Technical Bulletin

Number: FAX-227

Model(s): FO-77
 UX-44 / 66

Subject: Dislocation of Platen Bearing

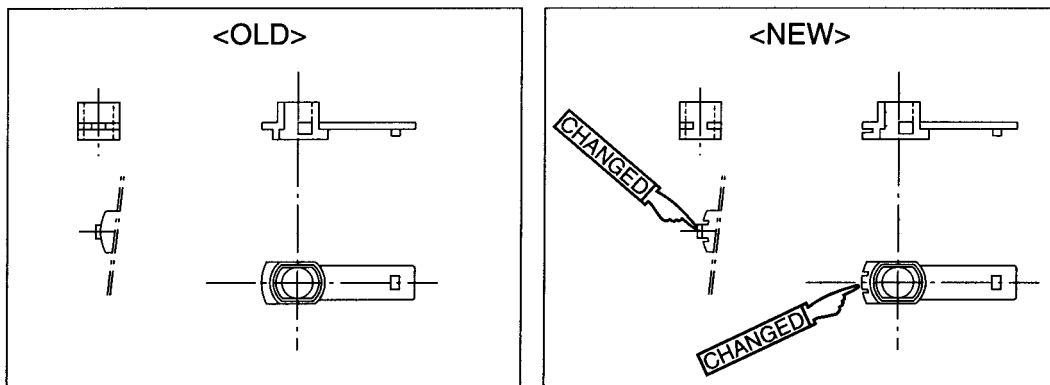
Symptom: The Platen Bearing may dislocate from the frame when dropped or subjected to strong vibration.

Cause: The Platen Bearing shape.

Corrective Action: The Platen Bearing shape has been changed.

**PRODUCTION CUT IN DATE:
 MARCH 2000**

Item No.	Model	Current Part Code	New Part Code	Price Rank	Description	Inter-changeability
1	All listed	LBSHP2112XHZZ	LBSHP2112XHZA	AA	Platen Bearing	1
Interchangeability						
1. Interchangeable				4. Not interchangeable		
2. Current type can be used in place of new type. New type cannot be used in place of current type.				5. Interchangeable if replaced with same types of related parts in use.		
3. Current type cannot be used in place of the new type. New type can be used in place of current type.				6. Others.
